UNITED STATES PATENT AND TRADEMARK OFFICE

APPLICATION NO.	FILING DATE	FIRST NAMED INVENTOR	ATTORNEY DOCKET NO.	CONFIRMATION NO.
10/695,360	10/28/2003	Anthony J. Bonfardeci	MOTP:102US	5974
24041	7590	09/20/2005	EXAMINER	
SIMPSON & SIMPSON, PLLC 5555 MAIN STREET WILLIAMSVILLE, NY 14221-5406			RODRIGUEZ, WILLIAM H	
			ART UNIT	PAPER NUMBER
			3746	
DATE MAILED: 09/20/2005

Office Action Summary

DETAILED ACTION

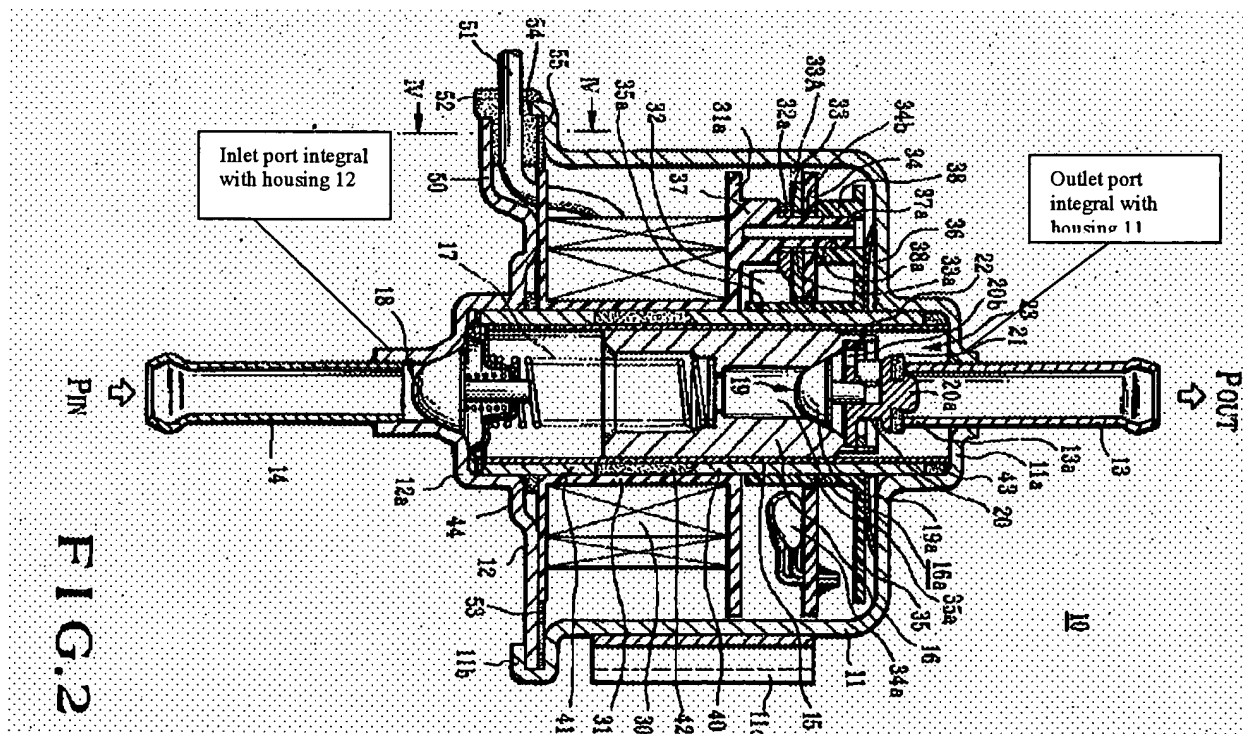
With respect to claim 1, **Masaka** teaches an electromagnetic fuel pump, comprising: a pump; electronic switching circuitry (column 6 lines 51-57) for controlling an electromagnetic coil 30 operatively arranged operate said pump; and, a housing (11, 12) arranged to house said pump and said coil, said housing comprising an integral (see column 3 lines 29-33) inlet port and outlet port. See particularly **Figure 2** above.

With respect to claim 8, **Masaka** teaches that the inlet port further comprises a bore; wherein said bore is operatively arranged for adhesion to an inlet fuel hose coupling nipple 14. See particularly **Figure 2** above.

With respect to claim 11, **Masaka** teaches that the outlet port further comprises a bore; wherein said bore is operatively arranged for adhesion to an outlet fuel hose coupling nipple 13. See particularly **Figure 2** above.

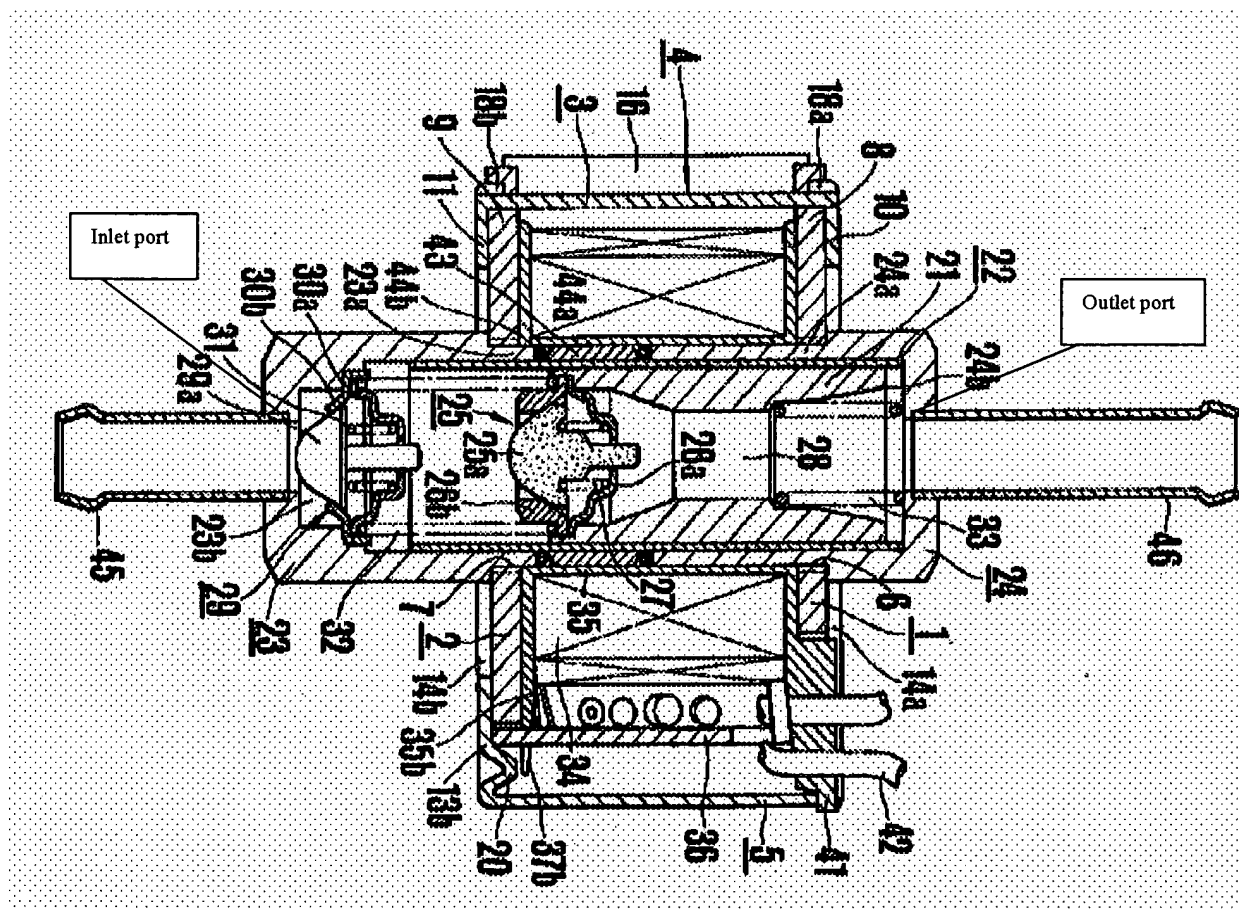
With respect to claim 8, **Masaka** teaches that the inlet port further comprises a bore; wherein said bore is operatively arranged for adhesion to an inlet fuel hose coupling nipple 45. See particularly **Figure 1** above.

With respect to claim 11, **Masaka** teaches that the outlet port further comprises a bore; wherein said bore is operatively arranged for adhesion to an outlet fuel hose coupling nipple 46. See particularly **Figure 1** above.

With respect to claim 12, **Masaka** teaches that the housing comprises structural hardening means (1, 2). See particularly **Figure 1** above.

With respect to claim 13, **Masaka** teaches that the structural hardening means comprises a metal shield (1, 2) within said housing. See particularly **Figure 1** above.

With respect to claim 14, **Masaka** teaches that the metal shield comprises a metal screen (1,2) within said housing. See particularly **Figure 1** above.
